NORTHERN STATES POWER COMPANY
MONTICELLO NUCLEAR GENERATING PLANT

REQUEST FOR AMENDMENT TO
OPERATING LICENSE NO. DPR-22

(License Amendment Request Dated September 30, 1977)

PROPOSED CHANGES TO TECHNICAL SPECIFICATIONS
APPENDIX A OF
PROVISIONAL OPERATING LICENSE DPR-22

Figure 3.11.1.1-A

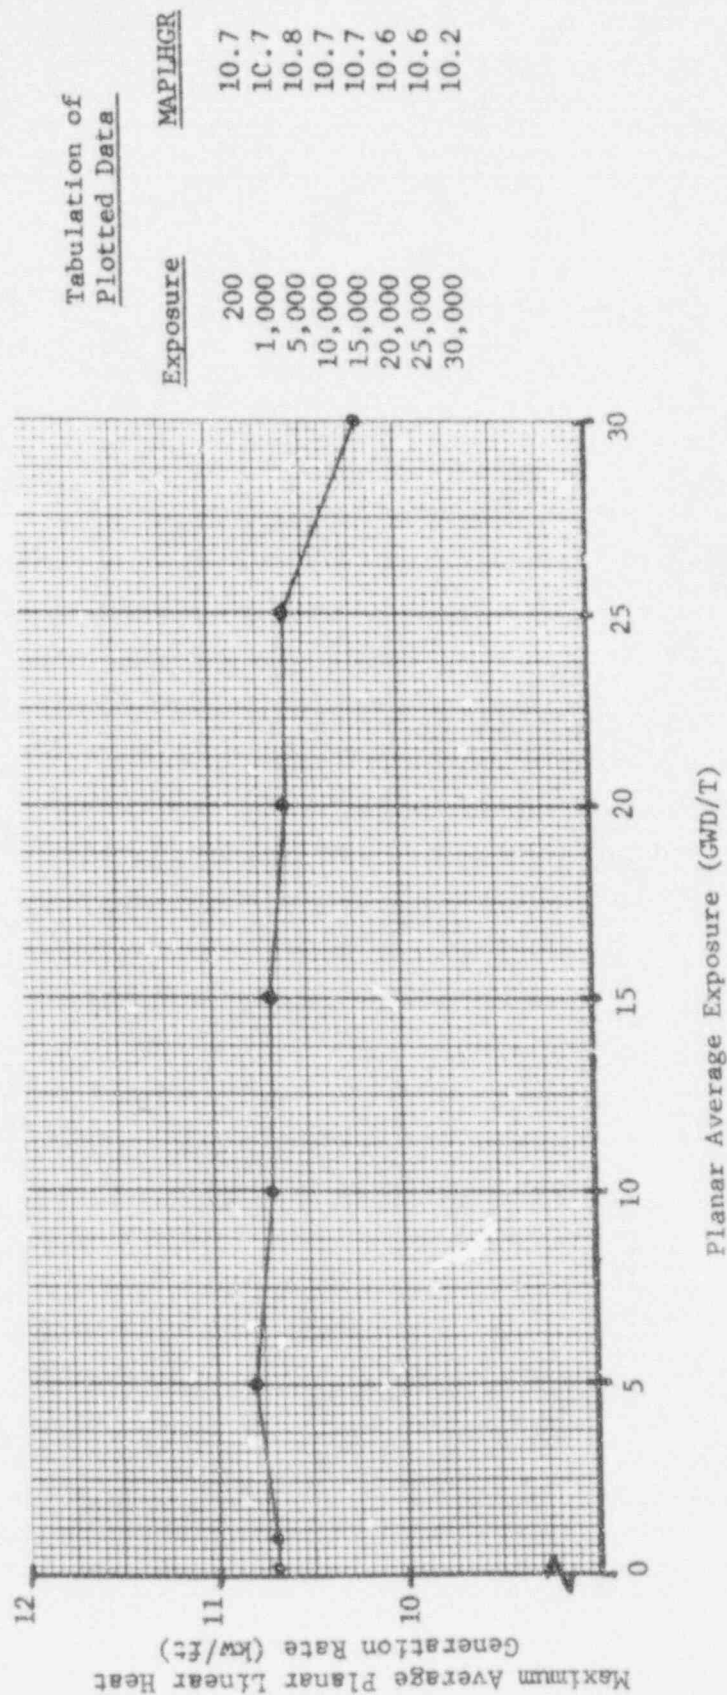
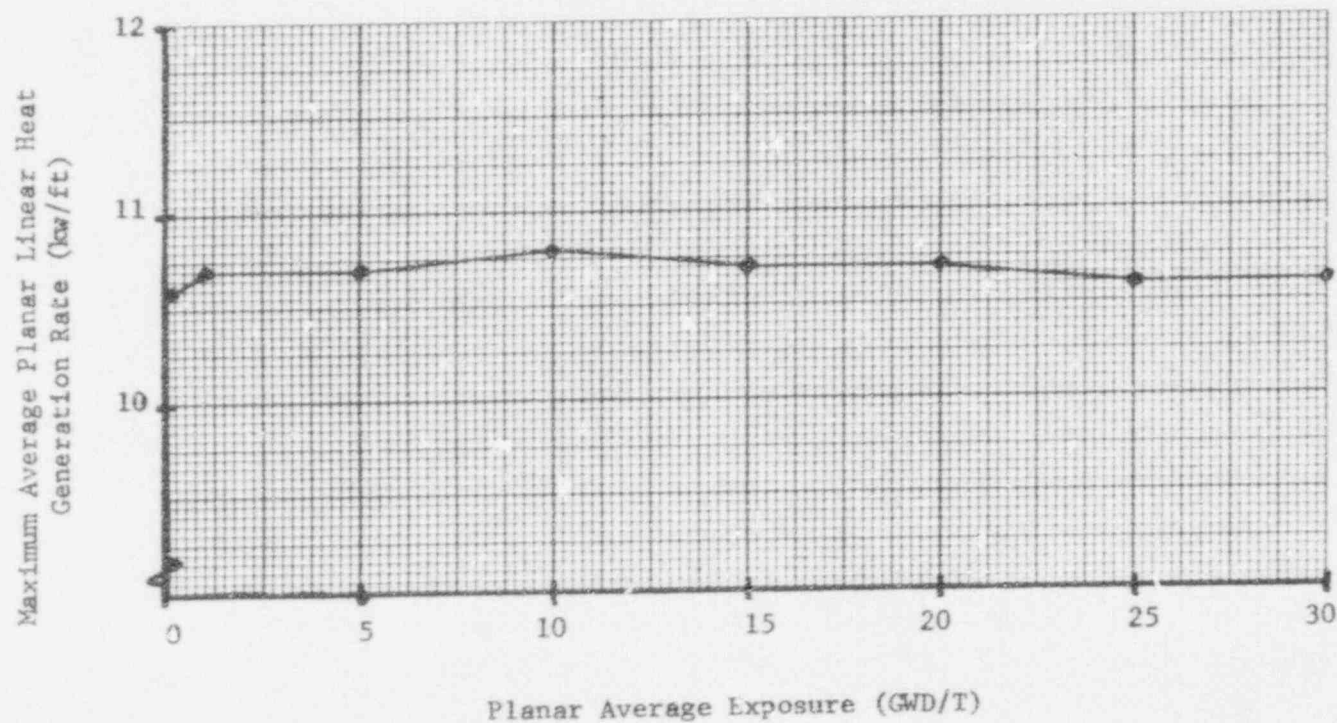
3. FIGURES 3.11.1-A, C and D and BASIS (Pages 189F, 189H, 189J and 189K)

Replace existing Figures 3.11.1-A, C and D of the Technical Specifications, Pages 189H, 189J and 189K, with the corresponding proposed figures included in Exhibit C. Replace Reference 4 on Page 189F with the reference, " 'Loss-of-Coolant Accident Analysis Report for Monticello Nuclear Generating Plant,' NEDO-24050, September, 1977, L O Mayer (NSF) to V Stello (USNRC) September 15, 1977".

The ECCS thermal limitations for the fuel types in service at Monticello have been re-evaluated using a newly approved model. The thermal limits are being adjusted and documented accordingly.
